FINAL
ENVIRONMENTAL IMPACT REPORT

MONTEREY COUNTY JAIL HOUSING ADDITION

State Clearinghouse # 2013011006

May 21, 2015

Figure 4
Site Plan

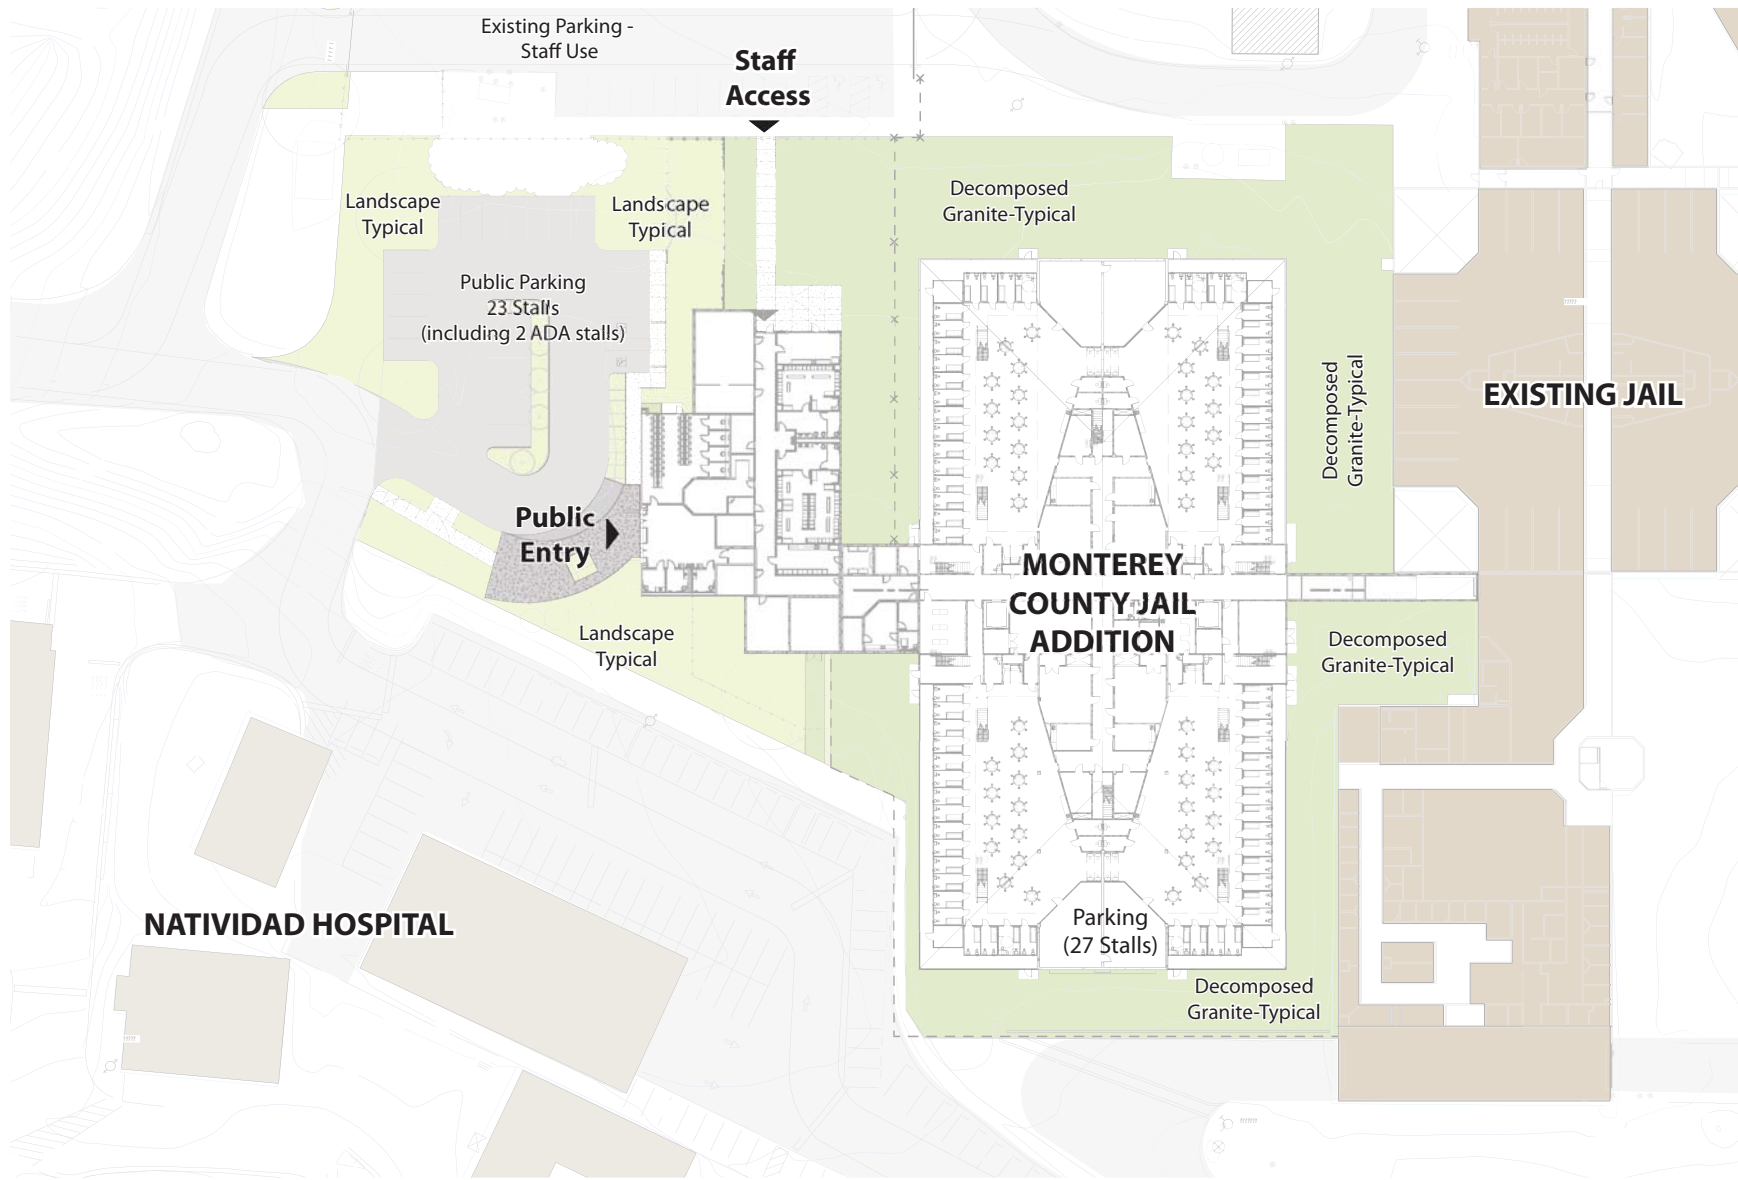
1. The hydrologic analysis set forth in the Technical Memorandum is based on a different, two phase, project that was initially described in the 2013 Initial Study, and is no longer being contemplated (see p. 2, Figures 2 & 3). The conceptual stormwater treatment plan (Figure 4) and conceptual utility plan (Scheme 4) that are attached to the Technical Memorandum are also based on this same two-phase project and building layout. However, as the 2014 DEIR explains in the Project Description, "the project will be constructed in one phase" and the site plan in the DEIR appears to show two buildings connected by a corridor in a configuration that is different than the site plan that was analyzed in the Technical Memorandum (See Figure 4). Accordingly, the Technical Memorandum and its related analysis must be revised and recirculated to reflect the current Project site plan to fully understand and address the effectiveness of the Project's drainage plan to reduce impacts, which is the conclusion of the DEIR. Importantly, it appears that the two-phase project analyzed in the Technical Memorandum includes a larger percentage of pervious coverage than the Project described and depicted in the DEIR.

Figure 4, Site Plan on page 2-15, and Figure 5, Site Plan – Aerial View on page 2-17 of the Draft EIR are revised to reflect current refinements to the project design including a small decrease in building footprint and re-orientation of the buildings on the project site as identified in the revised text above.
